PBOT Evaluation of Build v No Build conditions for bicycling with the I-5 Rose Quarter Improvement Project

Using the Oregon Department of Transportation's (ODOT) Environmental Assessment (EA) of the I-5 Rose Quarter Improvement Project as its basis, this document offers the following:

Russell to/from Broadway Bridge

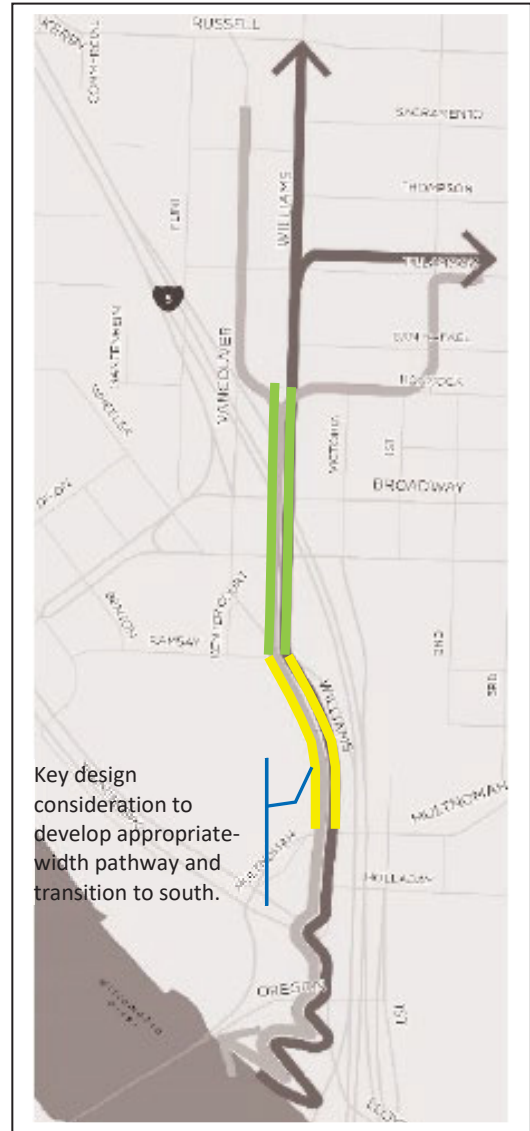
The only yellow segment—on N Dixon Street—indicates that people bicycling west along Dixon necessarily use a shared roadway segment west of Wheeler. This is a worse condition than in the No Build where people would use a protected bicycle lane on N Broadway.

While conditions on N Vancouver are the same in the Build and No Build, the green line indicates improvement because people use a buffered lane rather than the shared lane on N Flint.

Travel Route <i>(Russell to/from Larrabee-Broadway)</i>	Delay		Comments	Considerations for design
	Distance	# signals		
Inbound				
via Broadway	-	+2	Vancouver buffered lanes improvement over Flint shared roadway.	Bike box at Vancouver-Broadway will need to be of sufficient size to handle all bicycle traffic heading to Broadway Bridge
via Hancock-Dixon MUP	+450'	-	MUP improvement over Flint shared roadway. Increased distance mainly due to switchback pathway.	
via Hancock-Dixon	+110'	+1	Riding in shared roadway on Dixon is worse than protected bicycle lane on Broadway in No Build. Can avoid crossing Larrabee by using Ross or Benton to Broadway. MUP is ~9% downgrade	Dixon will be a shared roadway west of Wheeler. Improvements will be needed to fully leverage new roadway.
Outbound				
Via Weidler-Williams	-	+1	Two-way pathway on Williams is improvement over buffered bicycle lanes on Williams	Transition to left side bikeway on Williams at Hancock will require design attention. This will require sufficient storage for southbound traffic accessing from Vancouver.

Lloyd District to/from Steel Bridge

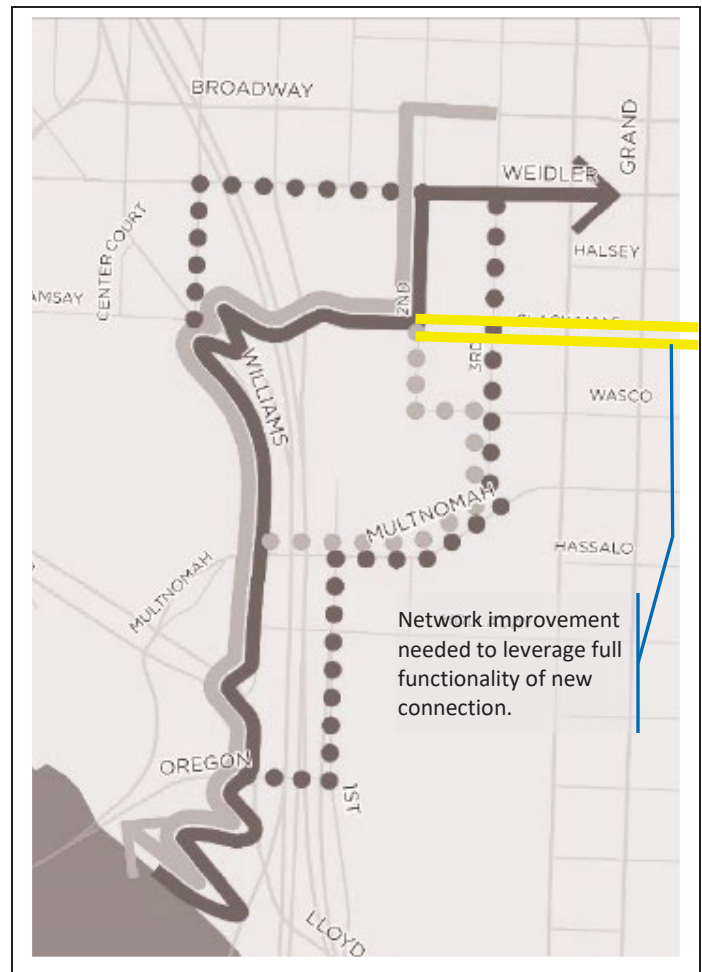
The Build scenario trip is longer but goes through one fewer signalized intersection than the trip for the No Build scenario.

Travel Route (Broadway/7th to/from Interstate/Williams)	Delay		Comments	Considerations for design
	Distance	# signals		
Inbound				
via Clackamas structure	+960'	-1	The No Build route assumes a path south to Multnomah, which is quicker than Broadway to the 2 nd Avenue neighborhood greenway. Because the Build route substitutes a shared roadway on Clackamas for a protected bicycle lane on Multnomah, that segment is worse than the No Build.	Clackamas is a shared roadway. Improvements would be necessary to fully leverage benefit of new bridge.
via 2 nd Avenue	+610'	-1	Shorter than using the Clackamas structure, the use of the shared roadway on Clackamas is worse than using the protected bicycle lane on Multnomah.	
Outbound				
via Clackamas structure	+960'	-1	Similar to inbound direction.	Same as above.
via 2 nd Avenue	+610'	-1	Similar to inbound direction.

Lloyd District to/from Steel Bridge (starting/ending at 7th & Clackamas)

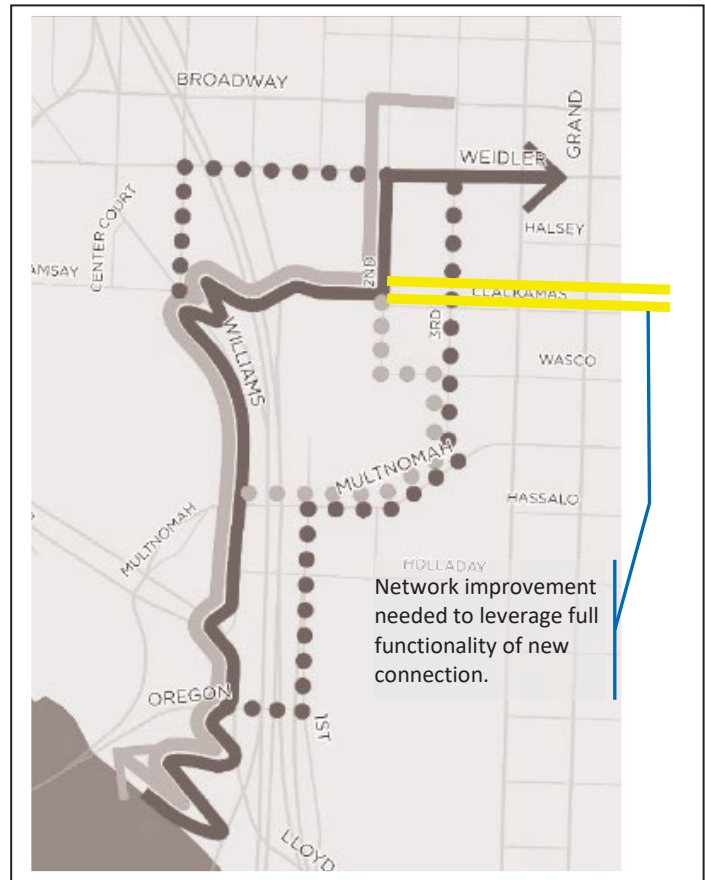
Because the No Build uses 7th bicycle lanes along 7th Avenue and a protected bicycle lane on Multnomah, the facilities along Clackamas (shared roadway) are worse.

Travel Route (Clackamas/7th to/from Interstate/Williams)	Delay		Comments	Considerations for design
	Distance	# signals		
Inbound				
via Clackamas structure	+960'	-1	Clackamas as a shared roadway offers a lesser quality facility than does 7 th and Multnomah.	Clackamas is a shared roadway. Improvements would be necessary to fully leverage benefit of new bridge.
Outbound				
via Clackamas structure	+960'	-1	Same as for inbound via Clackamas.	Same as above.
